DFCM Addendum #3

Reference: Bastian Equestrian Arena
DFCM Project #25401770
U3P Event #CS25039-Stage II

ADDENDUM NO. 1
April 14, 2025

USU Bastian Equestrian Arena

sheet:
C-300

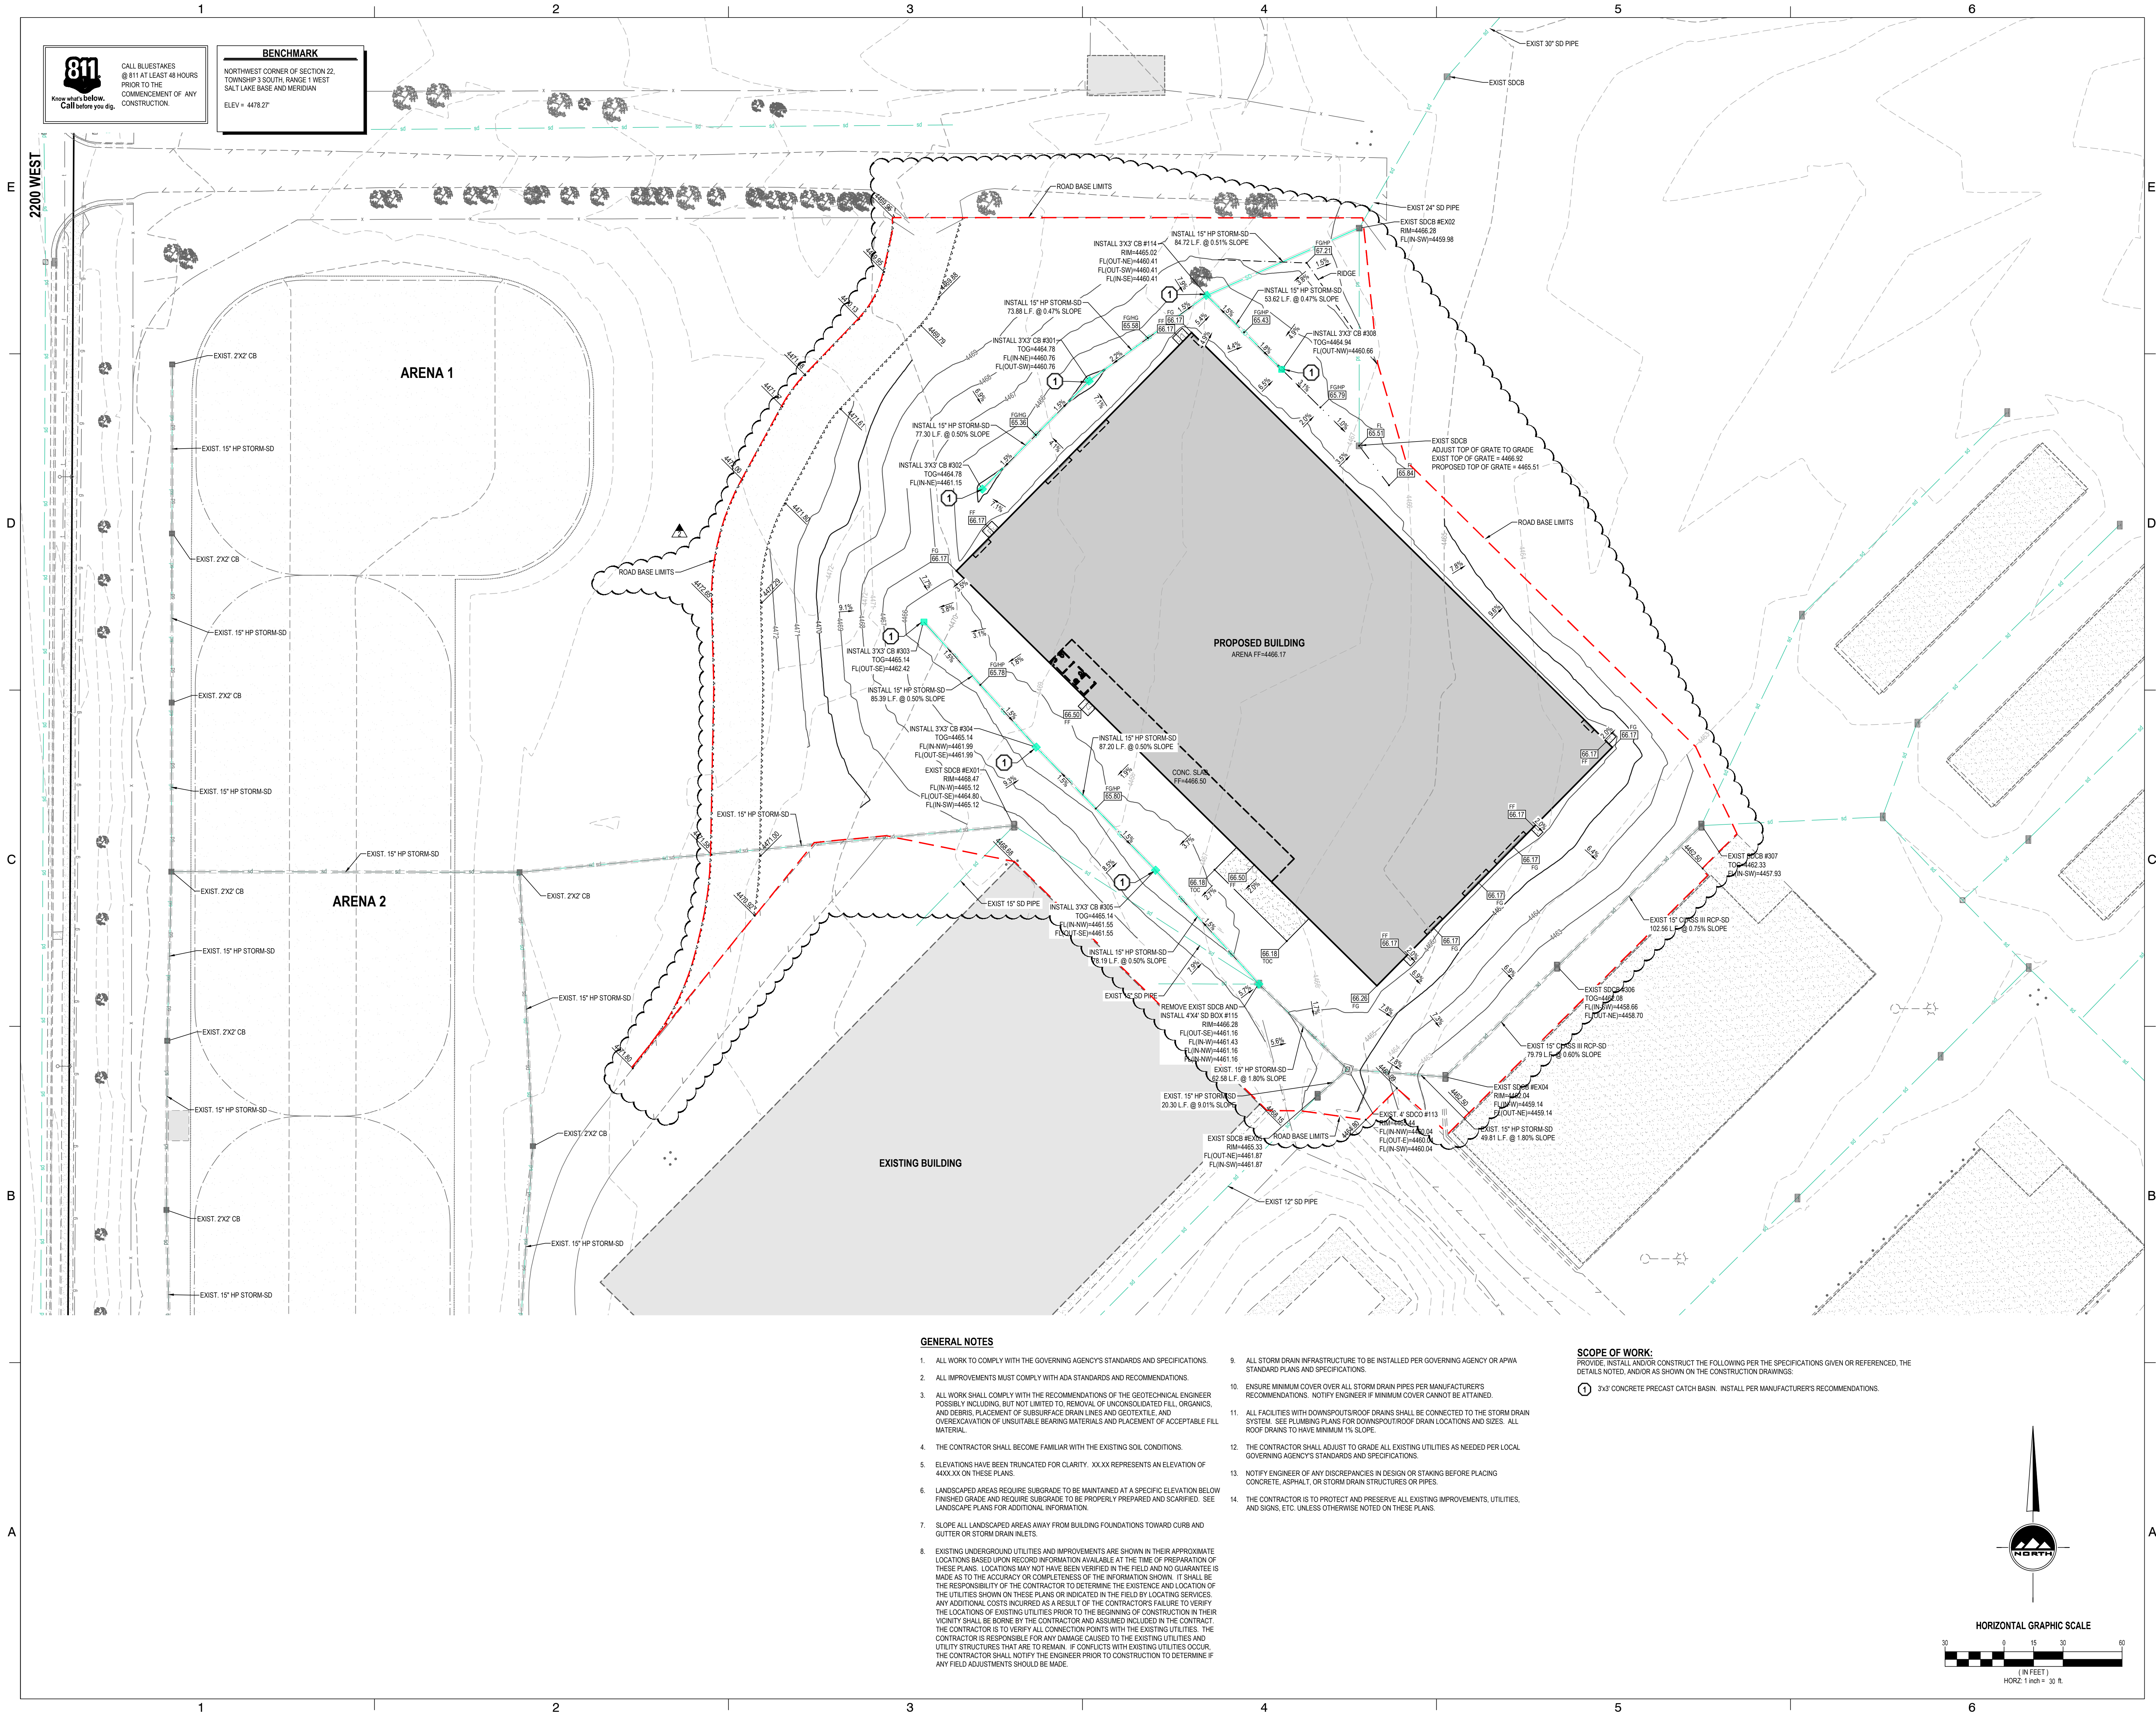
Question 004 - C300 – Verify grades shown on either end of the building are not too steep for truck/trailer loading and unloading at overhead doors.

Response: 8% is best practice as a maximum slope and we are under 8%

ROOF PLANS

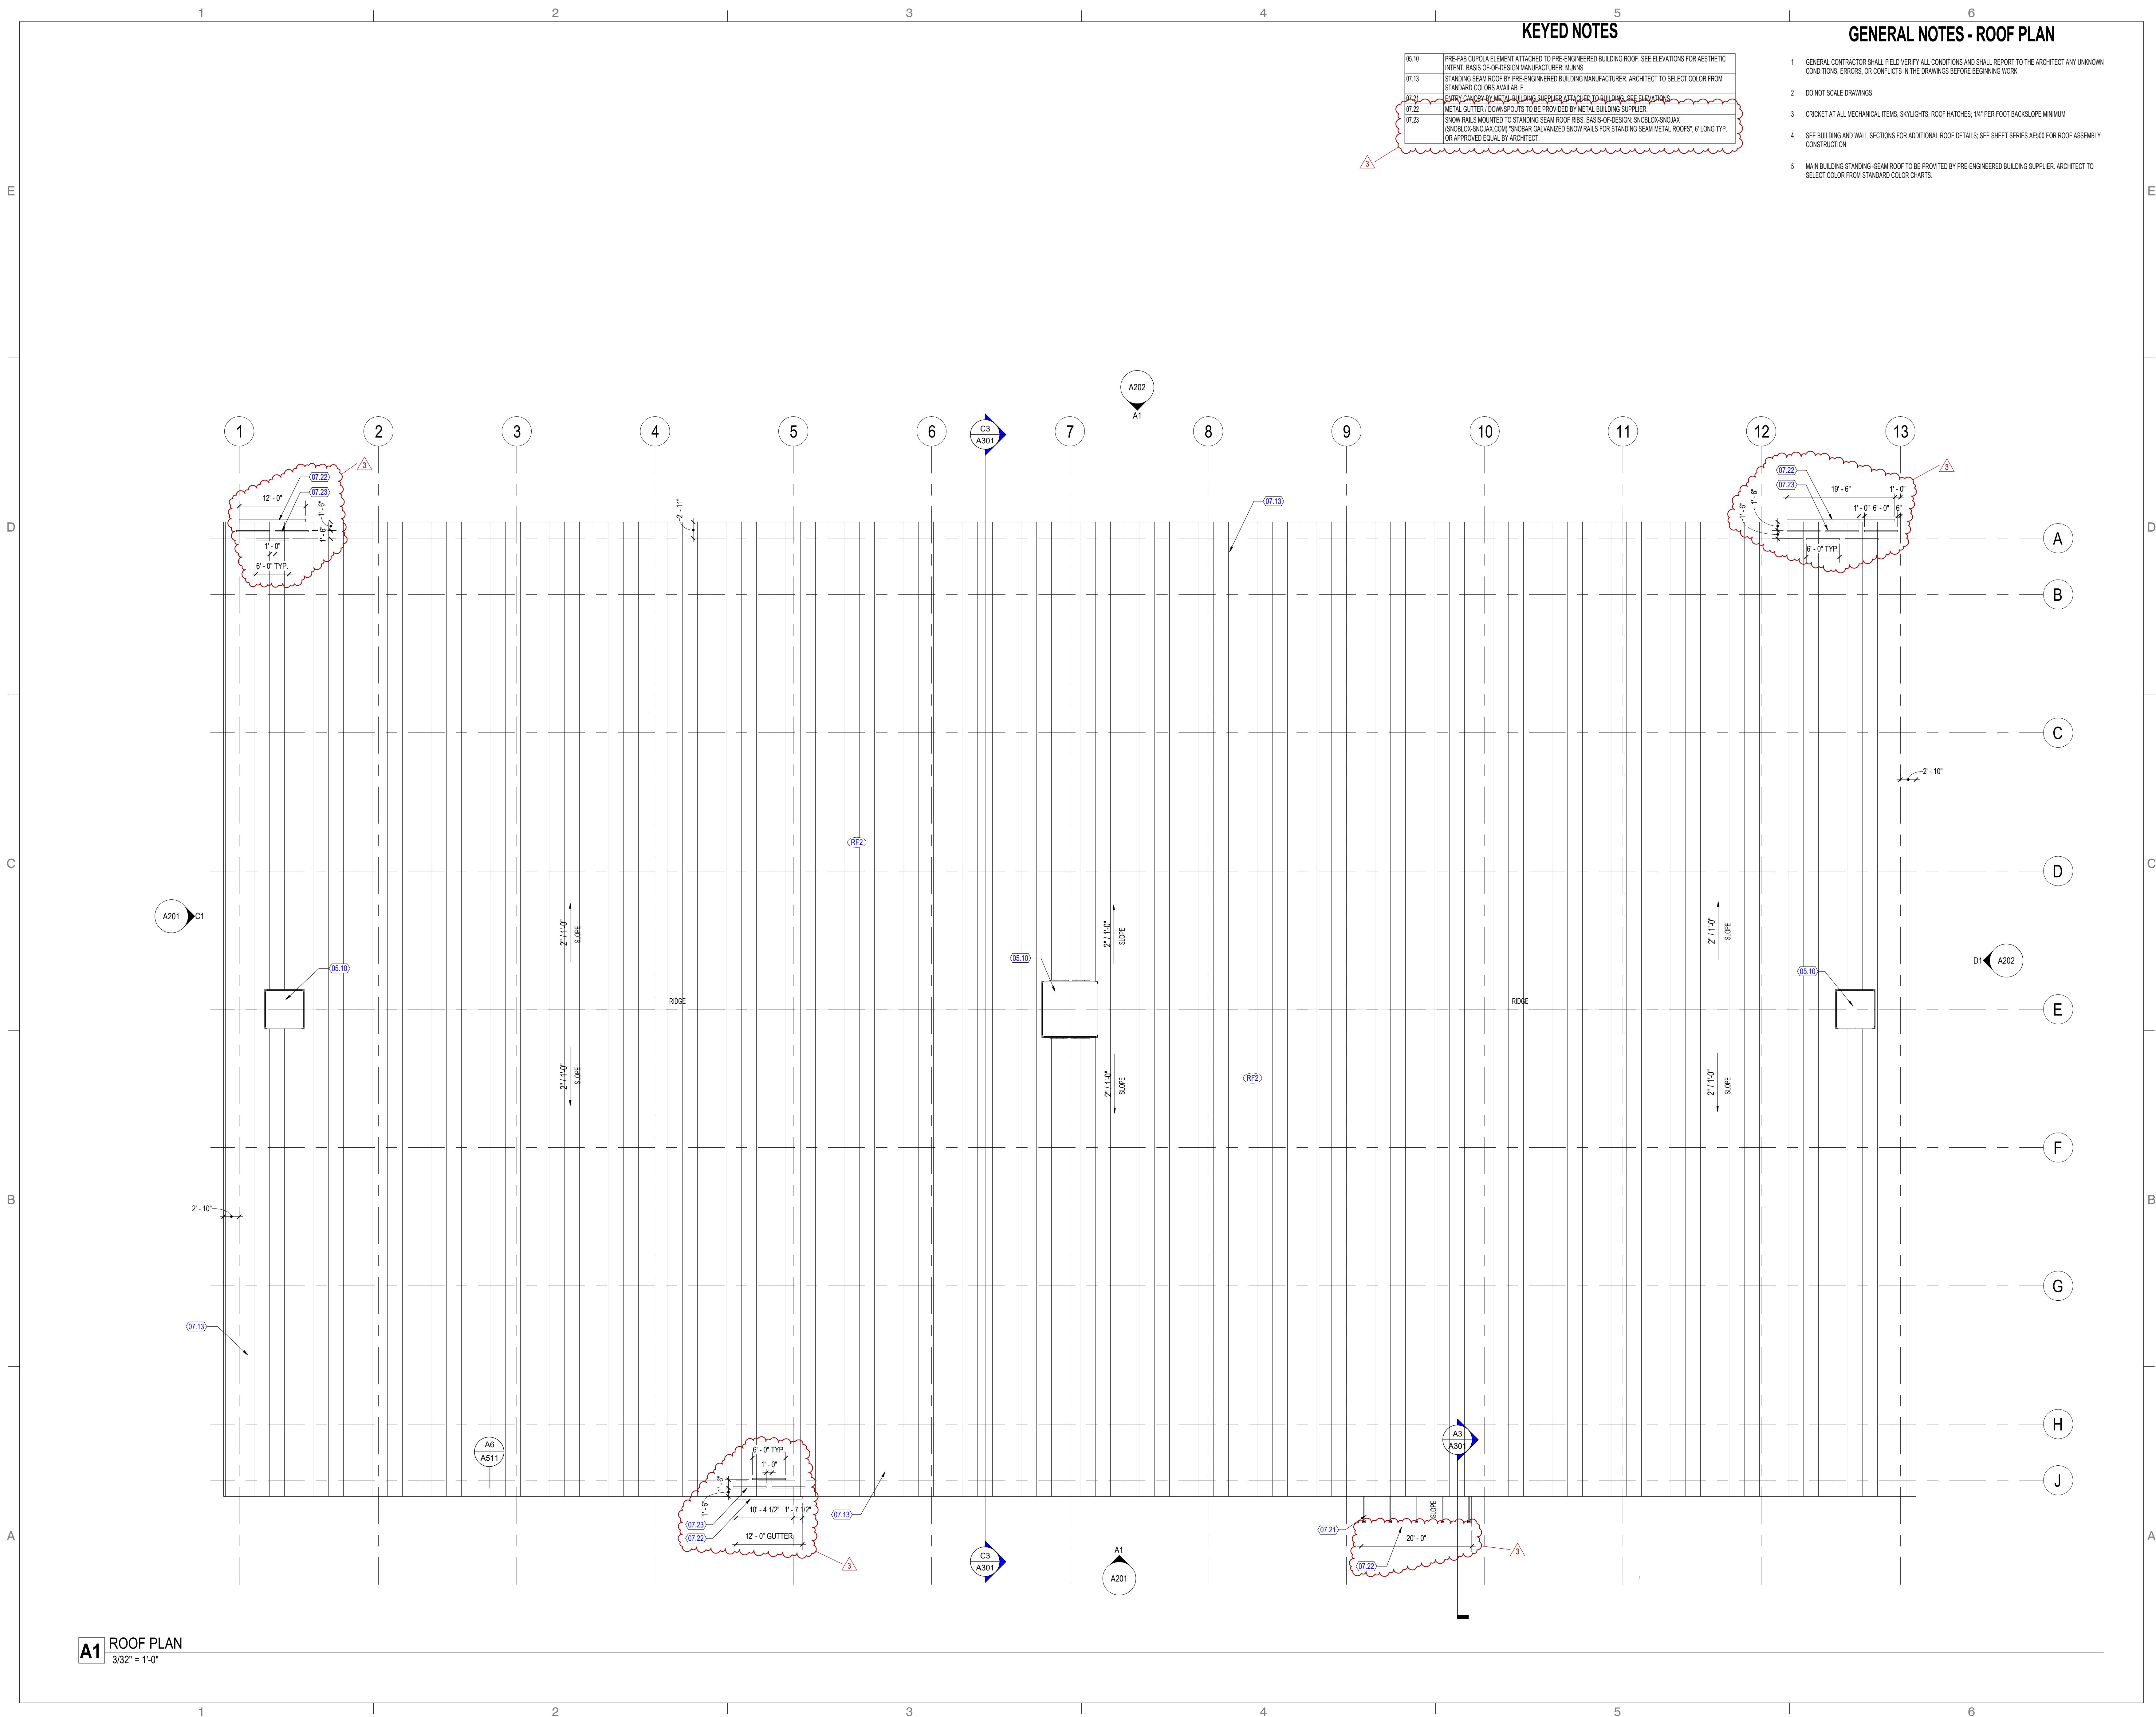
Question 006 - A201 – Do we need any guttering or rain/snow protection above door 100P?

Question 007 - A202 – Do we need guttering or rain/snow protection above doors on the northeast elevation – doors 100F, 100G, & 100H?

Response: The roof plan and elevation sheets have been updated to show a gutter and snow cleats above door 100P to address rain/snow protection for this door.

Response: The roof plan and elevation sheets have been updated to show a gutter and snow cleats above doors 100F, 100G and 100 H.
